**JOINT REGIONAL PLANNING PANEL
(Sydney East Region)**

ADDENDUM PLANNING REPORT

JRPP No	2012SYE035
DA Number	11/DA-21 REV03
Local Government Area	Hurstville City Council
Proposed Development	Section 96(2) modification to Stage 2 of "East Quarter" development - addition of two (2) x storeys to buildings A, & E, deletion of commercial floor space in Building B, associated facade and basement changes
Street Address	93 Forest Road Hurstville
Applicant/Owner	Applicant: Milestone (Aust) Pty Ltd Owner: East Quarter Hurstville Pty Ltd
Number of Submissions	Three submissions
Recommendation	Approval
Report by	Laura Locke – Team Leader Development Assessment

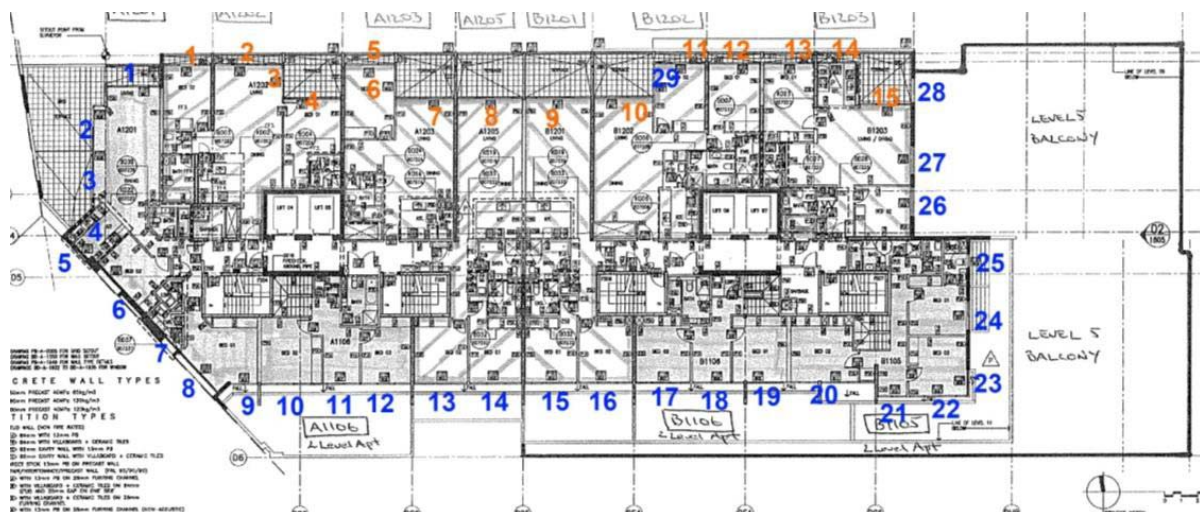
The deletion of the proposed two levels on Building B means that the Building is now the same height as originally approved by the Joint Regional Planning Panel. Council is now satisfied that the view towards the city skyline will be maintained.

The applicant has provided a view analysis demonstrating the view impact from the additional two storeys on Building A. The view analysis indicates that there will be some view loss towards the east to the airport and Botany Bay. Although there is some view loss, the vast majority of the views are maintained and this loss is not considered to warrant refusal of the amended application.

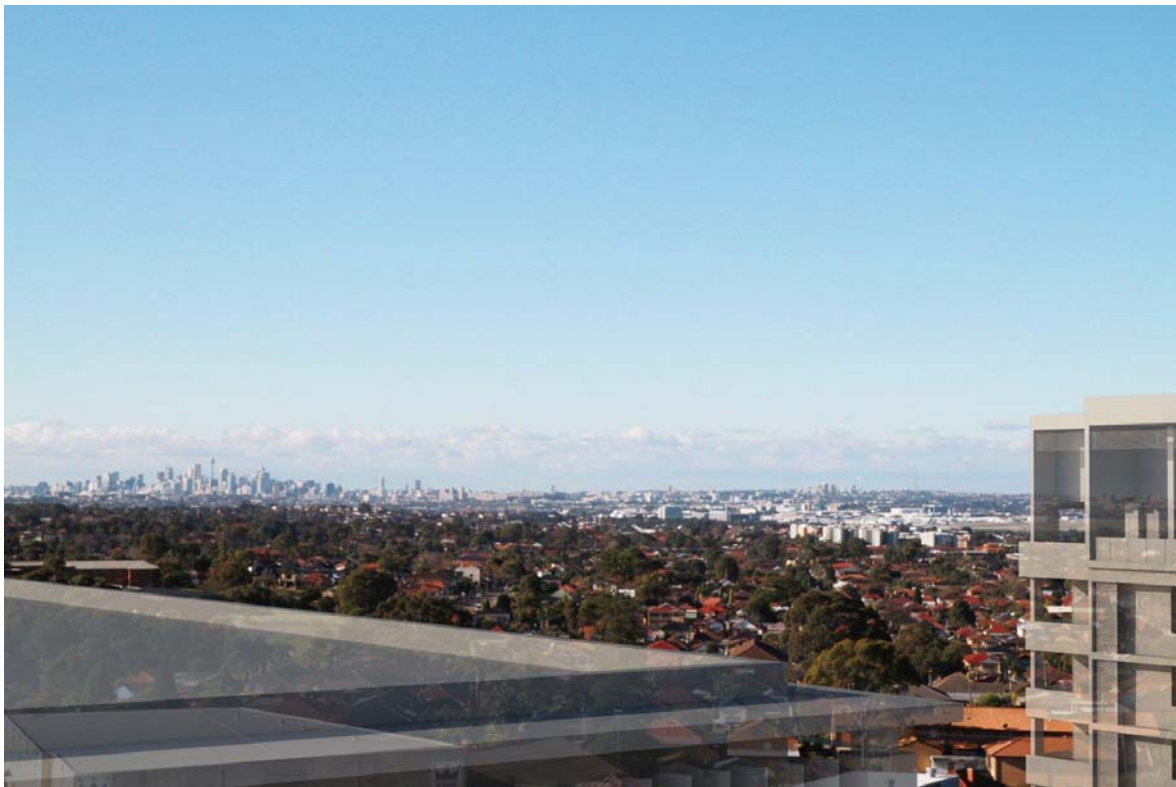
*The extent of the potential view impact to the east as a result of the proposed increased height of Building A is limited to 6 of the 10 units on Level 12 of Building D. These units are A1202, A1203, A1205, B1201, B1202 and B1203 located on the northern side of Building D (see **Figure 1**).*

The applicant has provided the following 3D view analysis demonstrating the extent of the impact on the worst affected unit in the existing Building D.

Although there is some view loss towards the east and north east the iconic view towards the city is retained. Further, the amount of view lost is minor compared with the proportion of view retained.
